Product Advisory Notice

Issue Date: January 25, 2023

Removal of Test Headers

Current

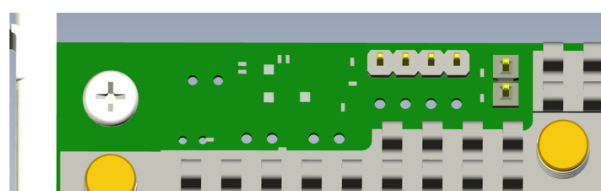
At production, test headers used during development and validation should be removed. The test headers on the 9600-24i and 9600-16i host bus adapters were not removed prior to production. These HBAs are being updated to not populate these headers. As part of this same change, the FW will be updated to the latest available version: MR 8.4.

There is no change to form, fit, or functionality.
